SECTION 53 COMMENTS NATIONAL GRID RESPONSE

Project	Waikanae North Development
Application reference	FTAA-2603-1194
Site	169-171 Peka Peka Road, Waikanae, Kapiti Coast
Document	Response to comments received under section 53, Fast-track Approvals Act 2024 National Grid
Prepared by	Joseph Harris, Landlink Ltd Ray O'Callaghan, O'Callaghan Design Ltd
Date	10 August 2026
Status	Final

2911- P0-055 -B

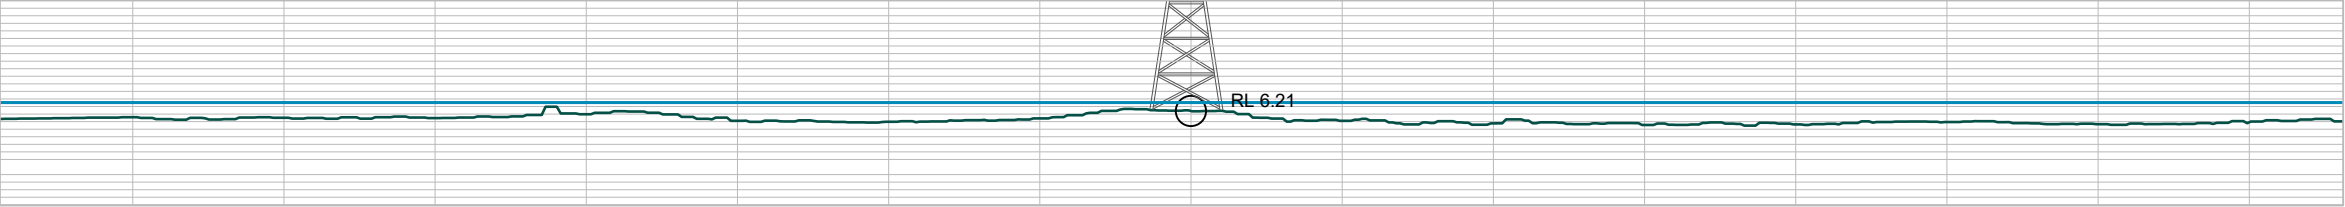
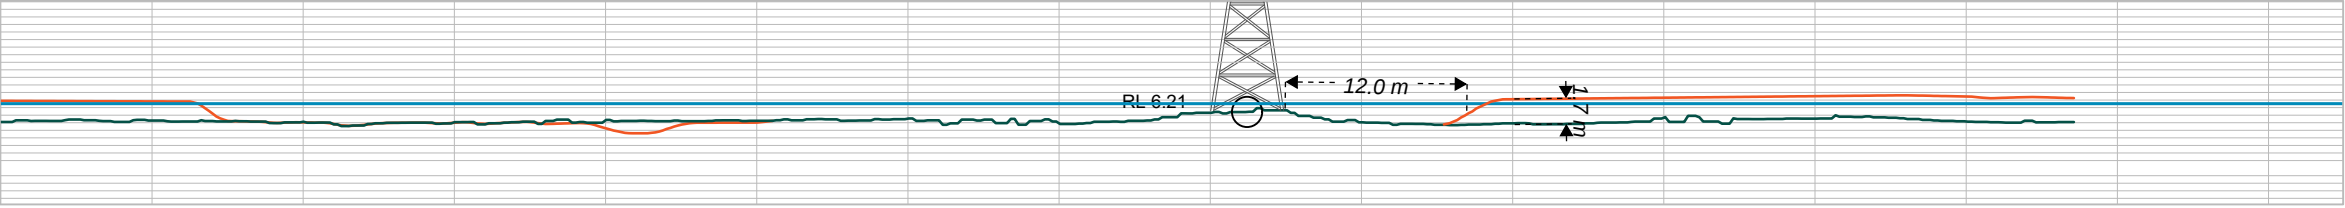
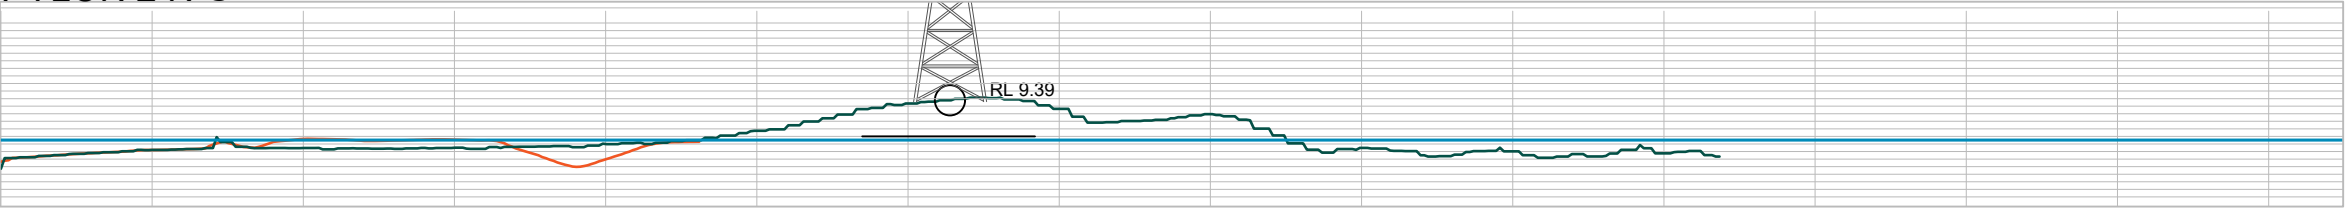
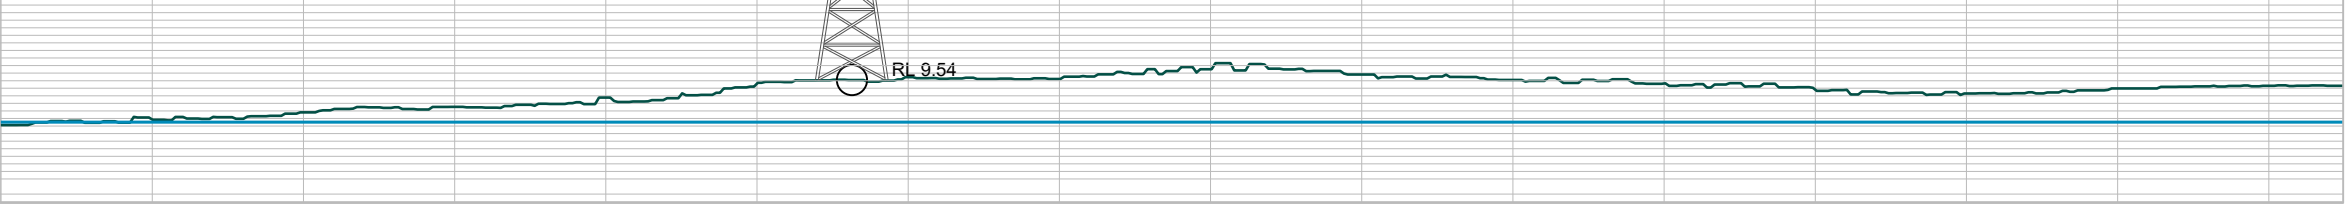
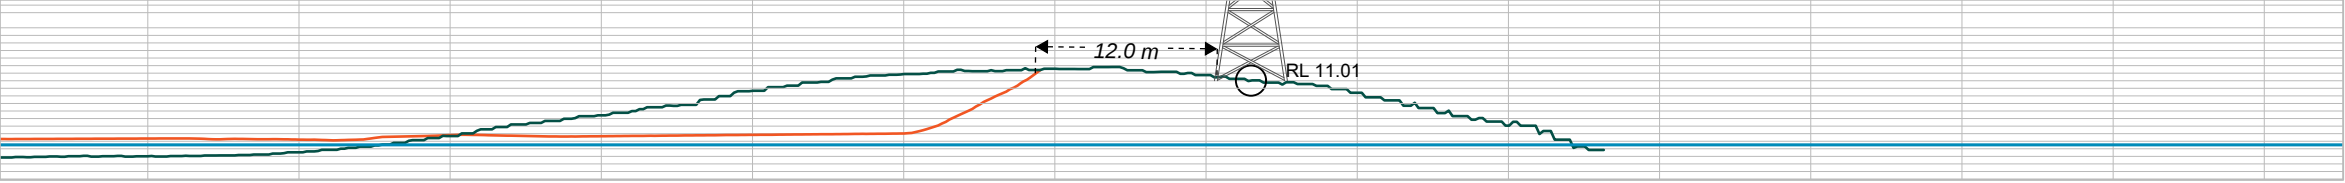
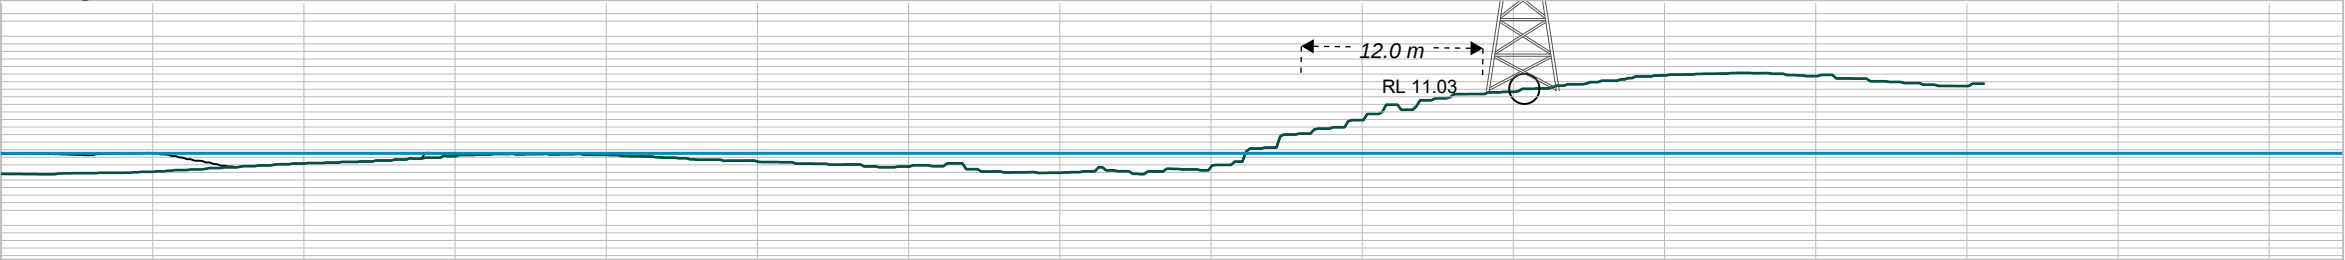
Comment. "Section 2.2.3 of NZECP34:2001 sets out the restrictions on excavation within 12 metres of the outer edge of tower foundations. Specifically, no excavation shall: (a) exceed a depth greater than 300mm within 6 metres... (b) exceed a depth greater than 3 metres between 6 metres and 12 metres... (c) create an unstable batter." ... "should the excavation not be able to comply... a dispensation will be required from Transpower (separate from the resource consent). There is no guarantee the dispensation will be provided..." (paras 4.18–4.19)

Response. A review of the pylon cross sections against NZECP34:2001 2.2.3 has been carried out. The preliminary design earthworks near the 5 towers on the site are shown in attached drawings 2911-PO-100, 045 & 055- Rev B. Stable batters (minimum 1V:3H unless otherwise certified) are the design basis for earthworks in the vicinity of each structure. As shown by the attached drawings, the requirements of NZECP34:2001 are met at all 5 towers. Transpower has proposed amendment to proposed condition 14 (KCDC consent condition) to specifically require earthworks to be in accordance with NZECP34:2001. WNDL agrees to this amendment and will update proposed conditions to confirm this matter.

Pylon 2 - BPE-HAY-A-0246

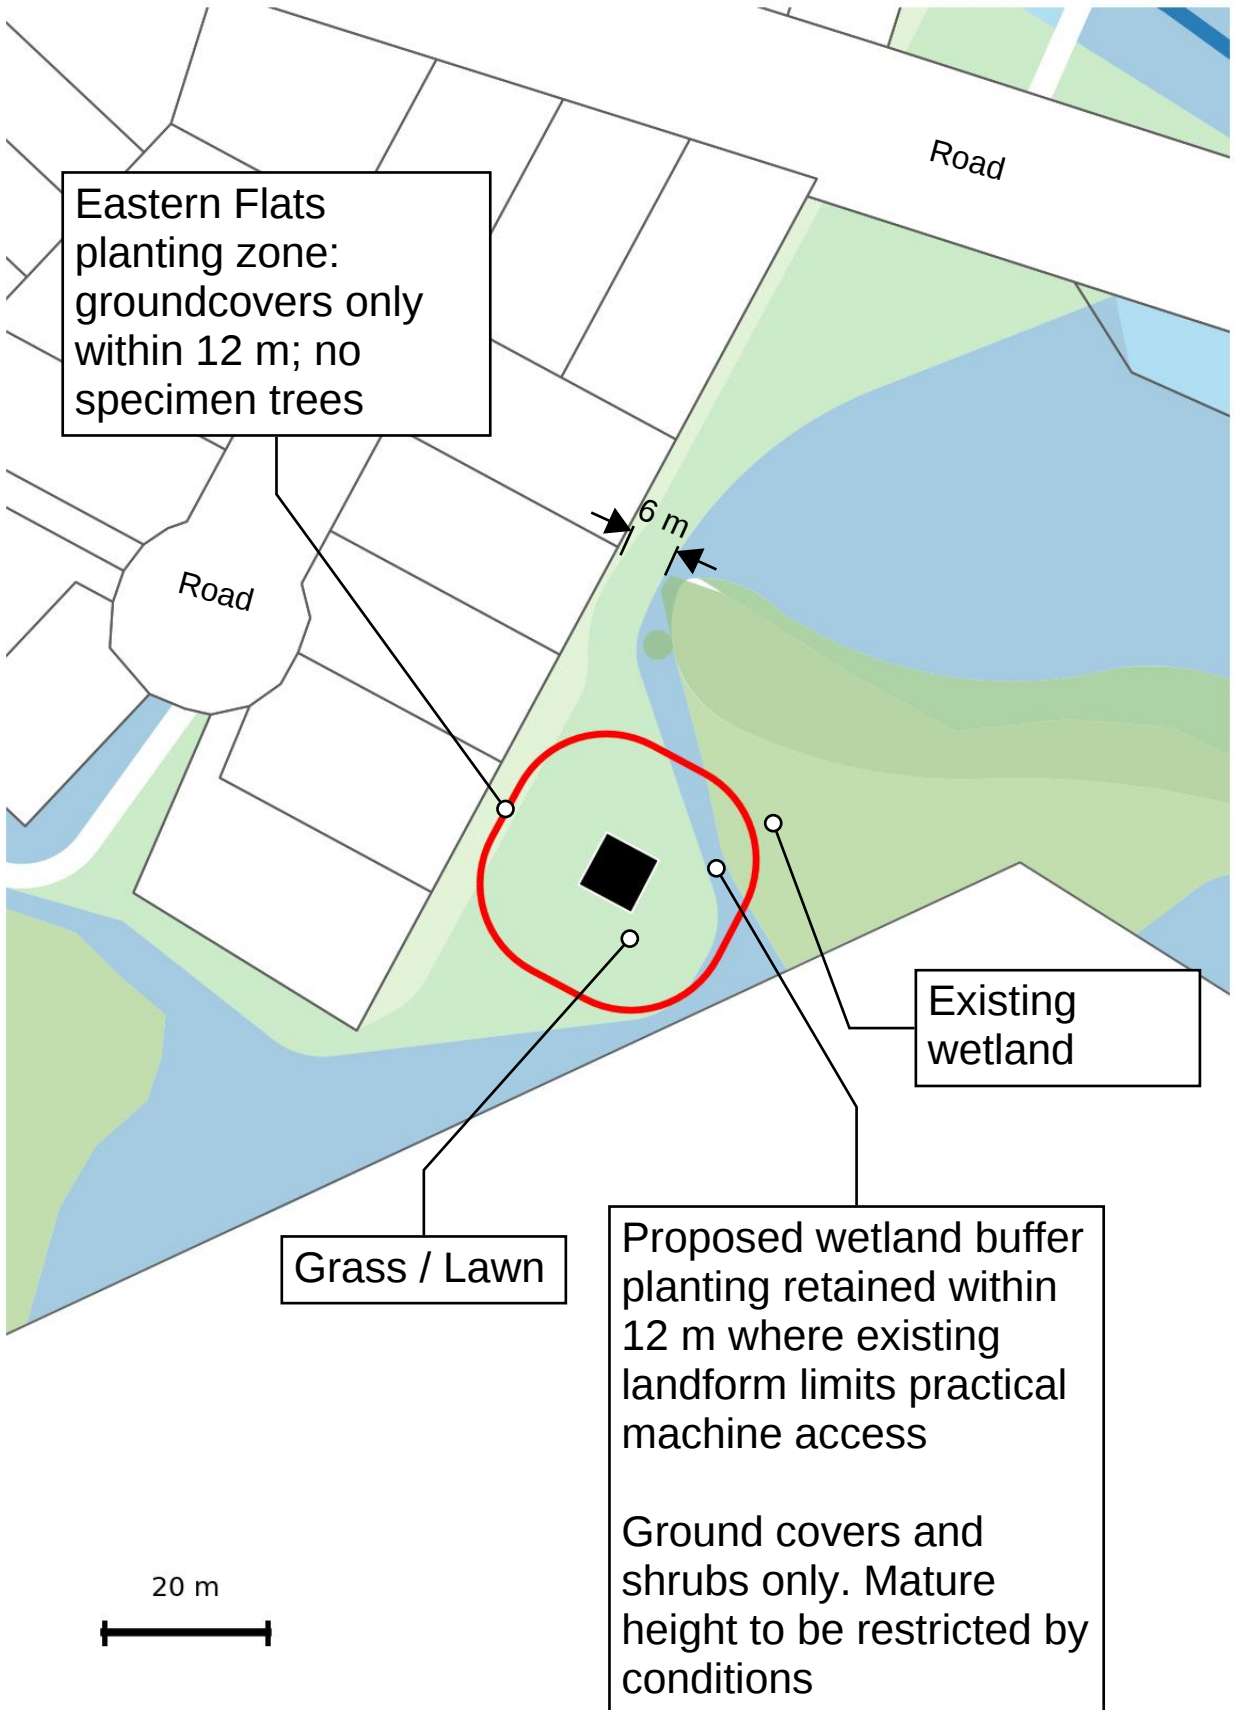
Comment. "Transpower requests the relevant Landscape Plans are updated to show the intended access tracks to assess suitability and ensure there are no impediments to access... Transpower is concerned around the provision of access to National Grid support structure BPE-HAY-A0247 within the Eastern Wetlands area, which is shown as being compromised due to wetland buffer planting and stream riparian planting. An access track from the adjacent road to the north, through to National Grid support structure BPE-HAY-A0247, with 12 metre working space around the structure, shall be shown on the Landscape Plan." (para 4.8)

Amend landscape plan:

provide grassed 12 m clearance/access area around pylon in place of wetland and drain buffer planting

Pylon 3 - BPE-HAY-B-0230

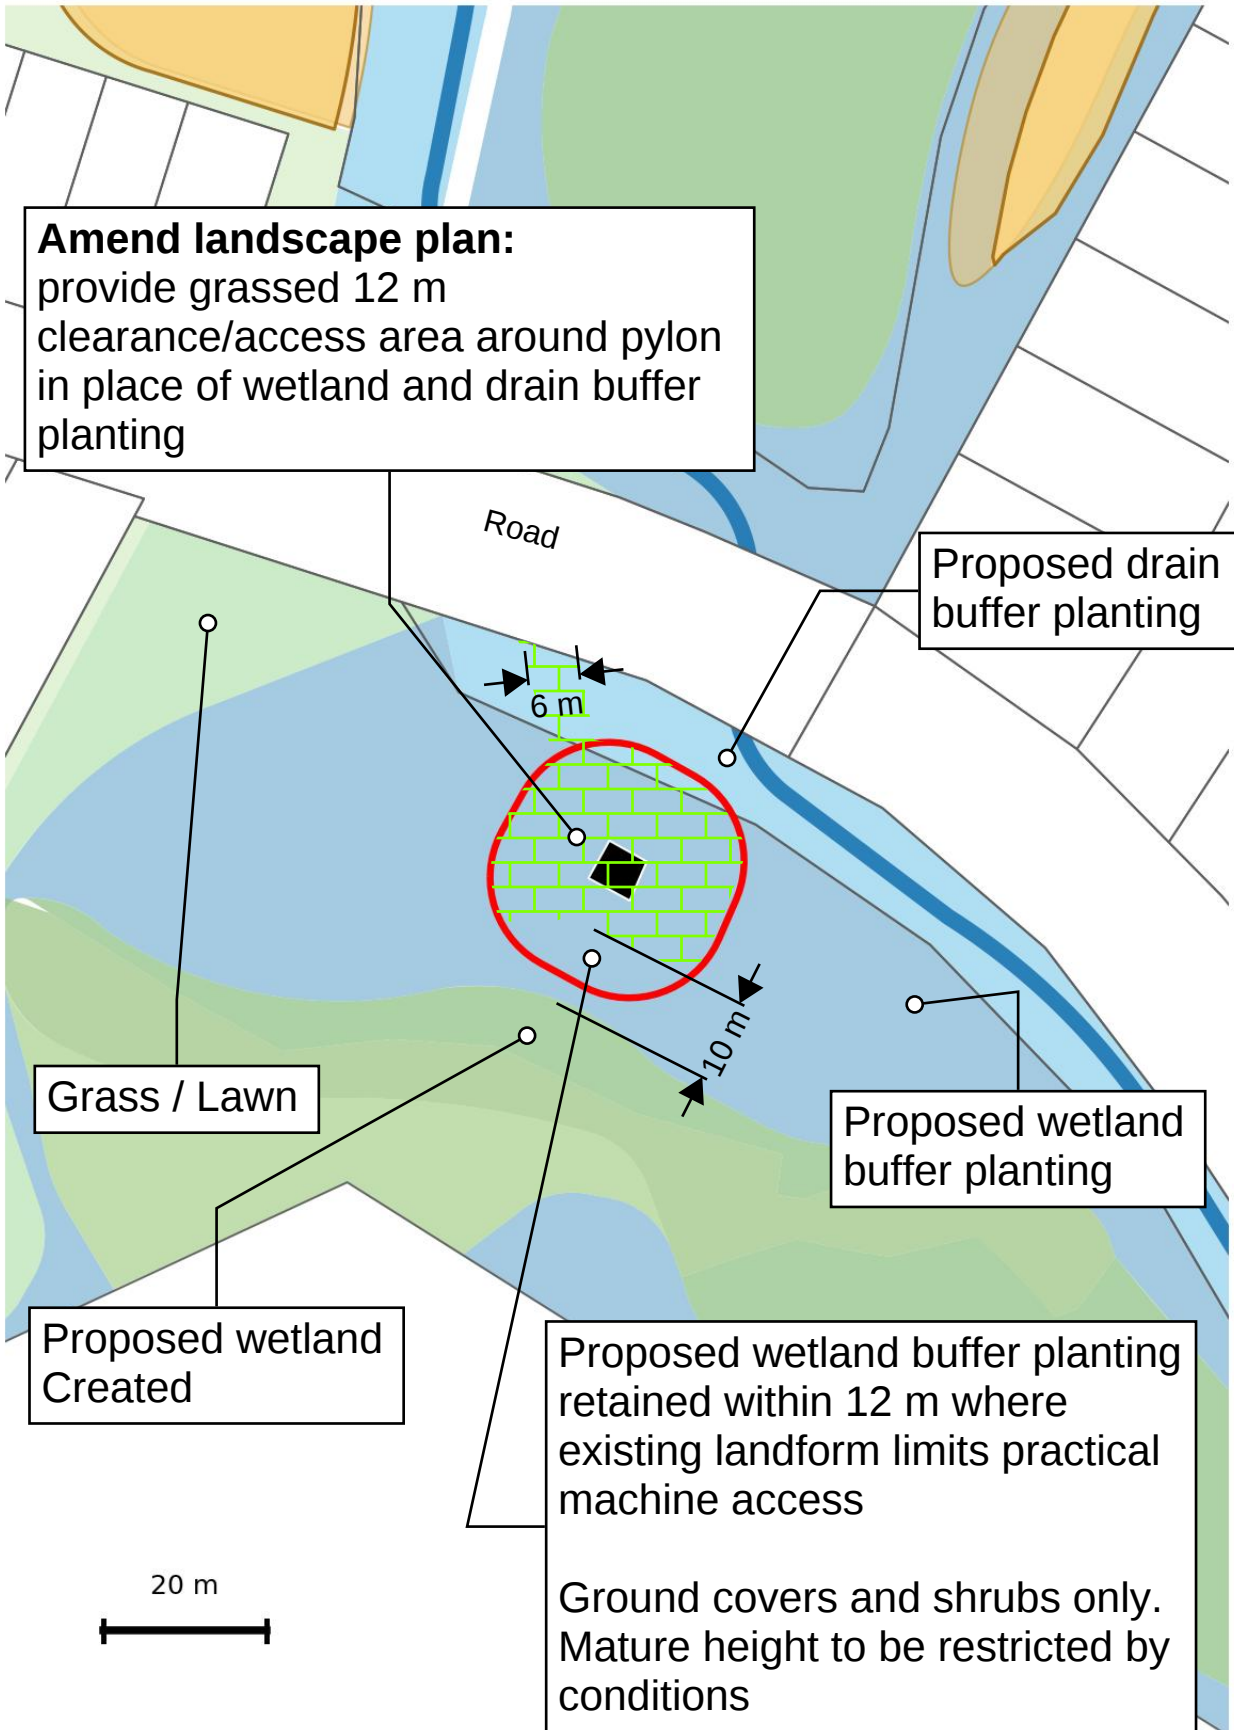
Comment. "...any new vegetation planted within the NGY should be less than 2 metres in height at full maturity... Any planting in proximity to National Grid support structures must be setback by at least 12 metres in order to provide Transpower with access for operation and maintenance activities." ... "species such as Kahikatea, Kowhai and Totara, which have the potential to grow over 2 m in height at maturity, could be planted within NGY." (paras 4.26–4.28)

Proposed wetland buffer planting retained within 12 m where existing landform limits practical machine access

Ground covers and shrubs only. Mature height to be restricted by conditions
